FINAL
CONST CERT
YC 027

Reference: 18th Hole Dam Evaluation and Construction Certification
Colonial Heritage
James City County, Virginia

James City County Environmental Division
Stormwater Management/BMP Record Drawing & Construction Certification Review
Tracking Form

Project Name: Colonial Heritage PH 1 BLVD.
County Plan No.: SP-75-02; AMEND SP-36-03
Stormwater Management Facility: MASTER PLAN POND #3, 9th HOLE POND (Form. 18TH HOLE)
BMP Phase #: ☐ I ☐ II ☒ III
☐ Information Package Received. Date/By: 04/26/06 AES
☐ Completeness Check:
- ☒ Record Drawing Date/By: 4/26/06 AES 4/24/06
- ☒ Construction Certification Date/By: ECS 6/25/03
- ☒ RD/CC Standard Forms (Required for all BMPs after Feb 1st 2001Only)
- ☐ Insp/Maint Agreement # / Date:
- ☐ BMP Maintenance Plan Location: Note 9, Sheet 20
- ☐ Other:

NEW LOCATION
PROPOSED
FORE BAY
STONE WALL
EXISTING
FORE BAY
STONE WALL
LOCATION

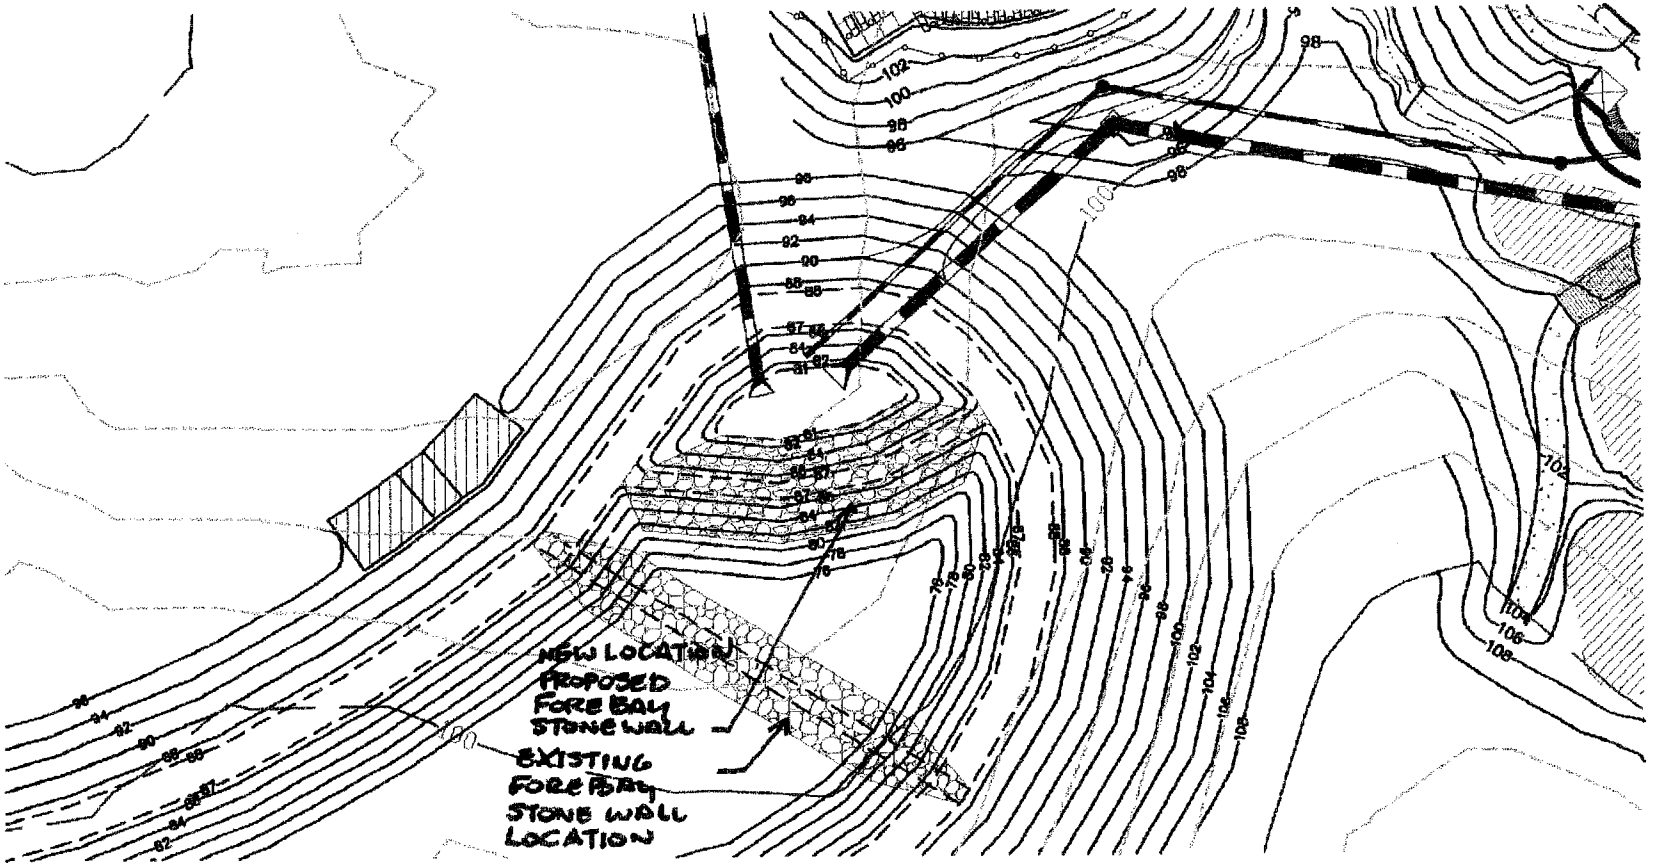
Revised forebay is acceptable. Plans needs to be amended to reflect the change - record drawings. DEC 2/19/03
